1. The specifications and drawings for Invitation No. DACW64-02-B-0025, Dredging and Marsh Creation, Channel to Liberty at Smith Point in Chambers County, Texas, Trinity River and Tributaries, Texas, advertised 31 May 2002 and for which bids are scheduled to be opened on 11 July 2002 are amended as follows:

BID OPENING DATE IS HEREBY RESCHEDULED FOR 2:00 PM LOCAL TIME, ROOM 175, JADWIN BUILDING, 18 JULY 2002.

In reference to questions from Contractors provided at a Pre-Bid Conference on 25 June 2002; 10:00 A.M., at the Galveston District Office, the following clarifications are provided:

TRINITY RIVER AND TRIBUTARIES, TEXAS
CHANNEL TO LIBERTY AT SMITH POINT
BUS NO.4 OYSTER REEF AREA
PLAN

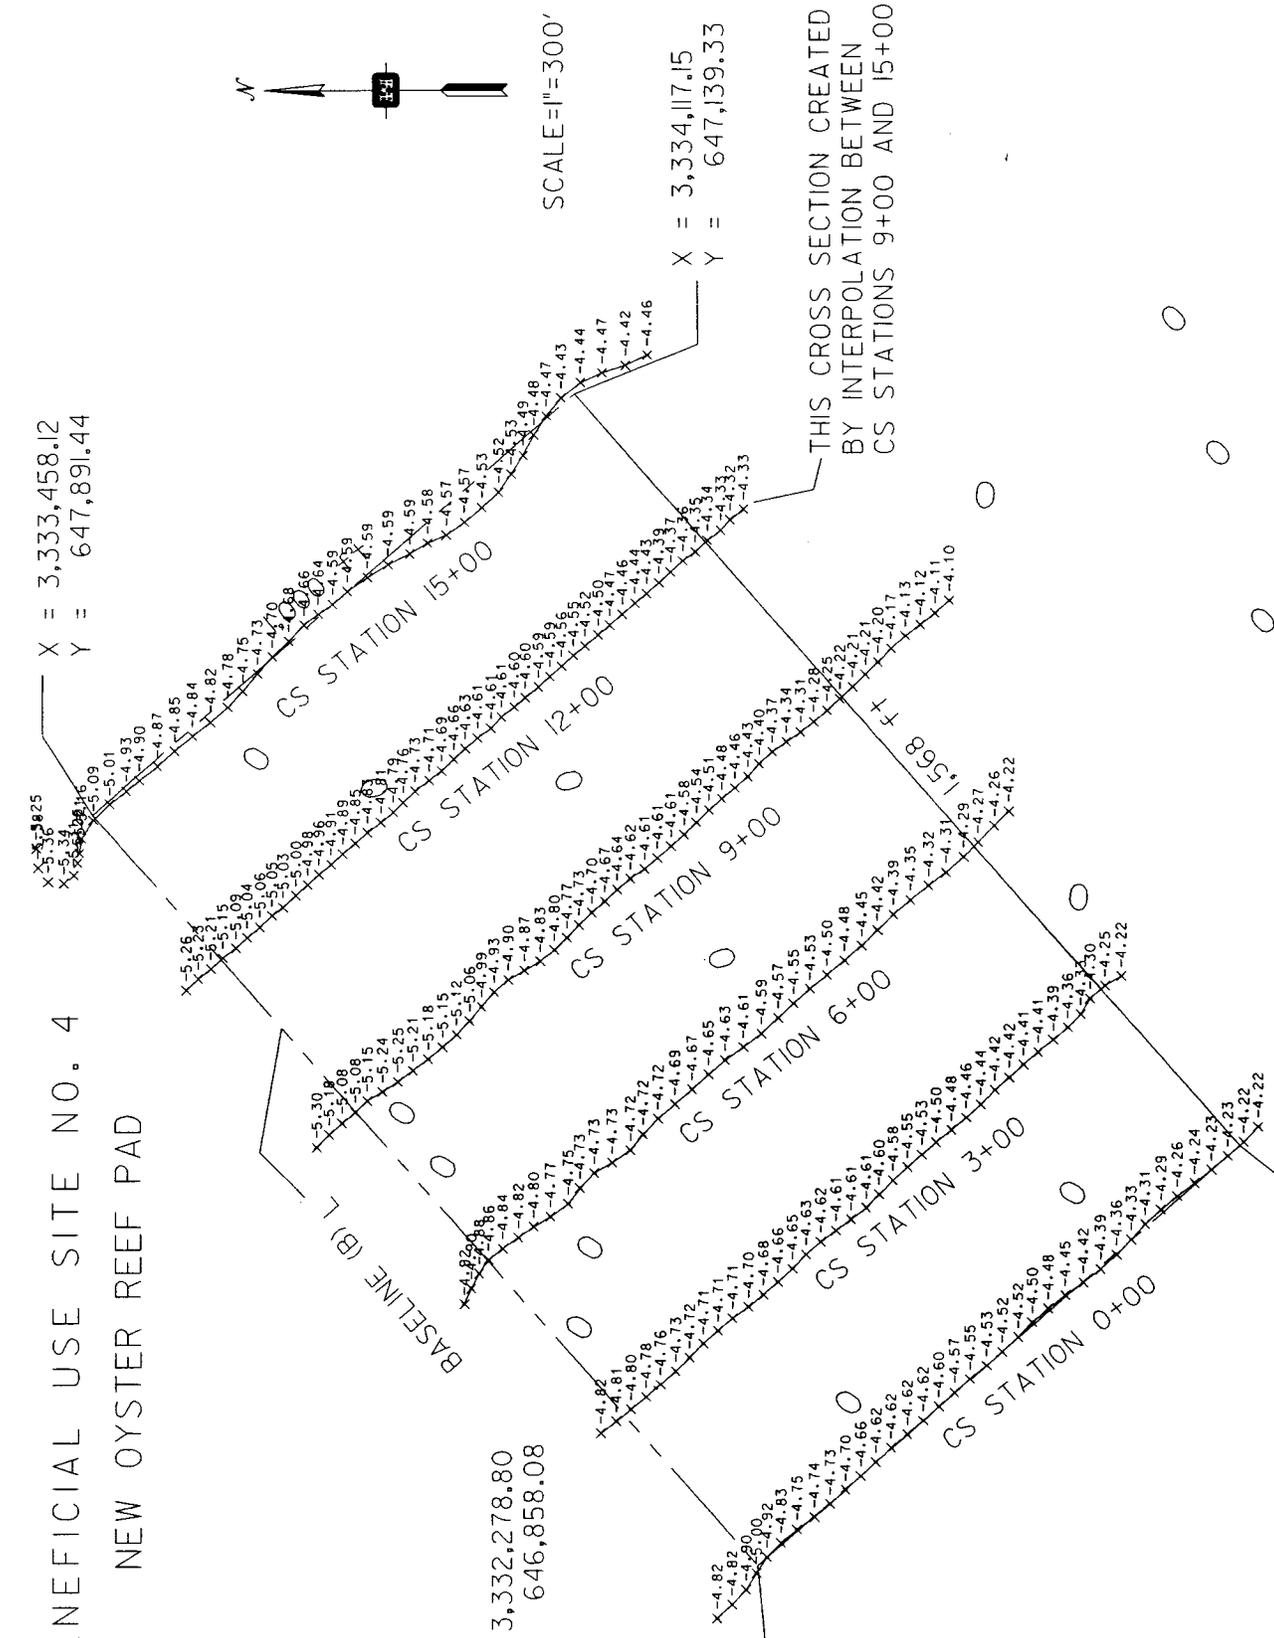
Q.13 Question No. 13 concerns the contractors' request for additional surveys at BUS No. 4.

" On the drawings Sheet 5 of 10, beneficial use of site for new oyster reef. Is it possible for us to be provided with any elevations, any existing elevations of that area? On the drawing Page 5 of 10 for the benefit of use Site No. 4, you don't supply us with any existing ground elevations and I'm asking is it possible for you to either put verbage in the specs about that or to have a survey?"

Q.14 Question No. 14 dealt with sheet 5 of 10 and what the "dots" represent.

" Are you familiar with this drawing? All right. All those little dots out here, what are they? Are you saying that these little dots is where there's 8 foot of water?"

A.13 Additional surveys were obtained in June 2002. Spot elevations of the area will be made apart of this Amendment No. 0003.

A.14 Yes, we are familiar with the drawing. The "dots" represent concentrations of hard bottom found by probing. No, the dots do not represent 8 foot of water depth per Mean Low Tide datum. This amendment will include a survey referencing elevations in these oyster shell-containing areas designated by dots to Mean Low Tide as a datum.

(3) SKETCH 13, - The enclosed new Sketch 13, showing soundings of BUS No. 4 shall be attached to and become part of this Invitation.
